REPORT OF INSPECTION 2024/5

by Joint Inspection Team for Building Safety (JIT)

**GARTH COURT,
Abbey Road, Llandudno. LL30 2HF**

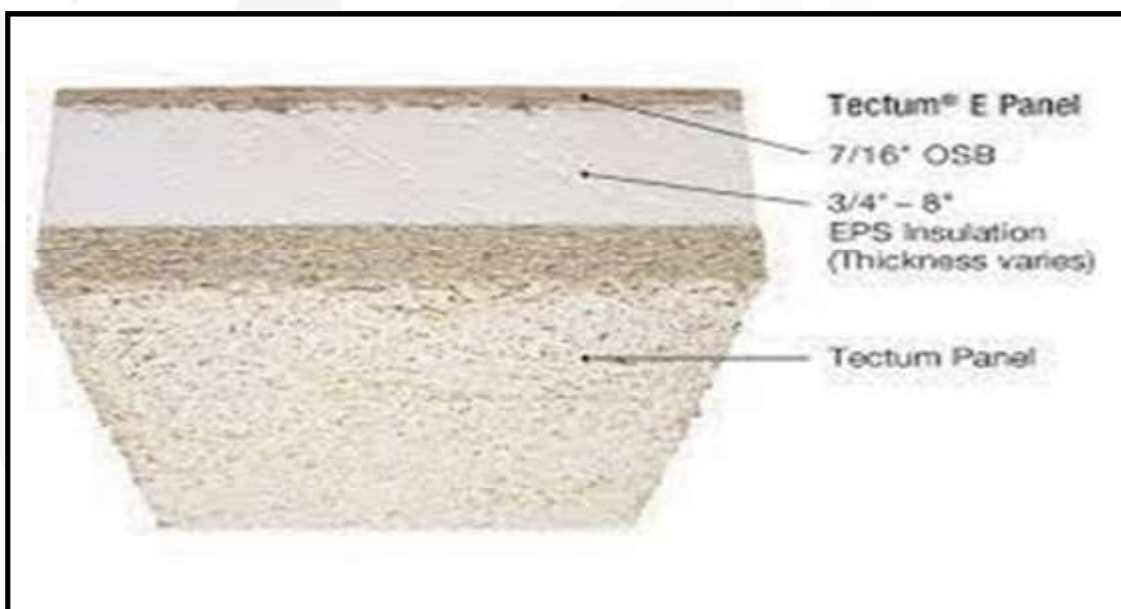
- 9.3 At Garth Court, recent works to the mansard section have raised concerns regarding the fire performance of the waterproofing system applied. The building features a steeply pitched mansard roof which, due to its angle and adjacency to occupied flats, falls within the definition of an external wall. Initial planning applications had been submitted for a full roof renewal, which would have included replacement of the entire structure. However, the most recent application proposed a scaled back scope of works, resulting in a more limited refurbishment approach. We have engaged with the local authority building control team, who provided their justification for accepting the revised works, including correspondence with stakeholders involved in the project. Although we have not seen a formal completion certificate, and no response has been received to our most recent communication outlining these concerns in full, the matter remains unresolved from a fire performance standpoint.

While the works have been framed as a like for like repair and the intention was not to alter the structure, the material used, Duracoat, is a polymer-based product containing solvents and is not supported by test data for use on vertical or near vertical wall applications. Although it has achieved BROOF(t4) under UK standards for flat roofing, this test is not recognised under EN 13501 for wall applications, and the product carries no Euroclass fire rating. Based on its composition, it would likely achieve a classification no better than Class D to F. The current BBA certificate for Duracoat clearly states it is not suitable for use on walls, which is significant given the fire risk associated with the mansard (wall) construction build-up.

The original build up likely included a bitumen felt with mineral finish, which may have achieved potentially low-class D with the mineral finish. However, this was laid over combustible backing materials typical of the construction era, such as OSB sheathing, EPS insulation, and wood wool board known as Tectum board, all of which contribute to fire loading and propagation. Importantly, while bitumen is combustible, it is a heavier oil derived material lower down the refining chain. In that sense, it behaves more like diesel when compared to highly volatile substances like petrol. Bitumen tends to ignite more slowly, requiring sustained exposure to heat before combustion, and typically has a more stable and delayed burn profile. In contrast, solvent based and polymeric coatings such as Duracoat are more volatile and can ignite quickly, increasing the rate of fire development.

The JIT believes the fire resistance of the mansard section has been marginally reduced and that overall fire risk has slightly increased as a result. This case presents an opportunity for learning and reflection, particularly where pitched surfaces form part of the external wall. It highlights the need to apply a more precautionary approach when substituting materials that lack test evidence or Euroclass ratings, and to reconsider the threshold between repair and alteration where fire safety is concerned.

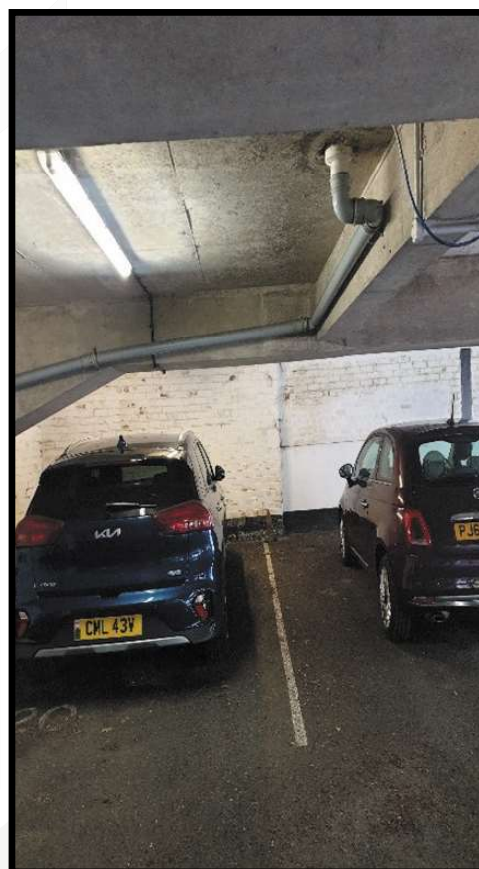
- 9.6 The lower ground floor car park is open sided, providing some natural ventilation, but several fire safety concerns were noted. There were multiple holes in the soffit of the floor slabs, including visible damage to the clay infill blocks and unsealed service penetrations. Soil stacks running through the area lacked fire collars at the slab junctions, leaving openings that compromise vertical compartmentation between floors. The general condition of the car park was poor, with signs of disrepair and inadequate house keeping, including the storage of combustible materials and general waste. The presence of electric vehicles introduces an increased fire risk, particularly due to the high energy release and difficulty of extinguishment associated with battery fires. In its current condition, the car park presents a number of risks that should be addressed through improved maintenance, reinstatement of passive fire protection, and a clear strategy for managing EV and ICE vehicle fire hazards.

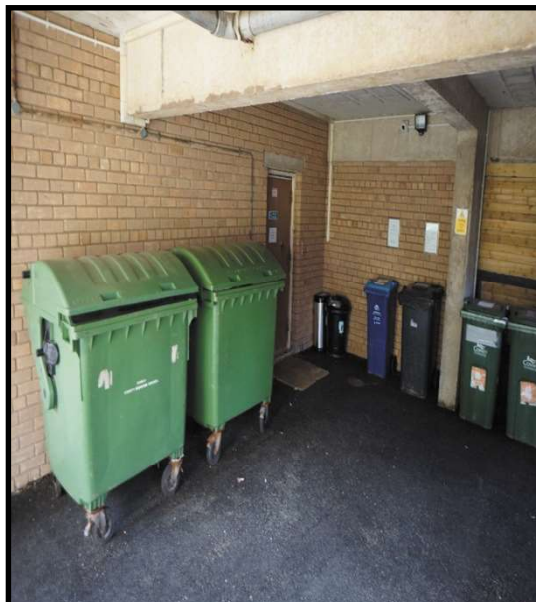
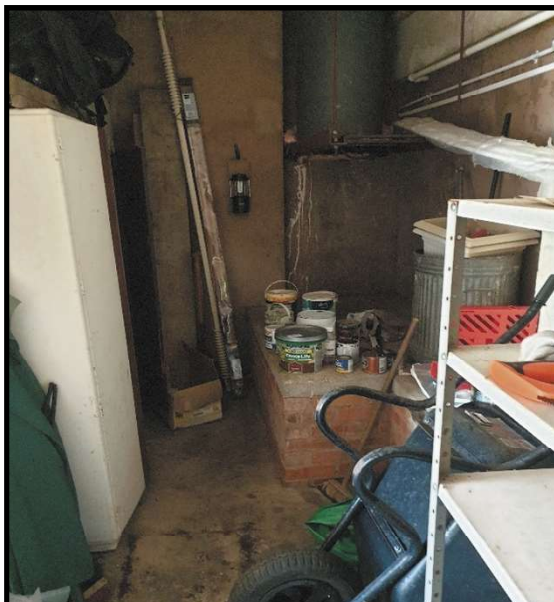
- 9.8 The bin chute formerly discharged into the waste storage room located at 1st floor level, where a manual chute shut off door remains in place. The chute has since been decommissioned, with the rear section sealed using expanding foam. This room has been repurposed as a general storage area and was observed to contain a notable quantity of combustible materials, including paints, cleaning products, plastic containers, and other general fire loading. The room is fitted with a fire alarm device, providing local detection coverage, and access is via double doors with louvred ventilation, offering some passive smoke dispersal. The original waste chute hoppers on each floor are likely behind a stud partition wall adjacent to the stair lobby.

The bins are now stored externally along the north elevation of the building in an area that is open and accessible to the public. While the space is covered by CCTV surveillance, its open nature presents a potential risk of arson, deliberate interference, or vandalism. The presence of combustible refuse in an unsecured area adjacent to the building increases exposure, particularly given the potential for ignition sources and the proximity to occupied flats. The arrangement should be reviewed to determine whether additional physical security measures or enclosure would be appropriate to reduce the risk.

- The JIT recommend that the bin waste storage arrangement should be reviewed to determine whether additional physical security measures or enclosure would be appropriate to reduce the risk.
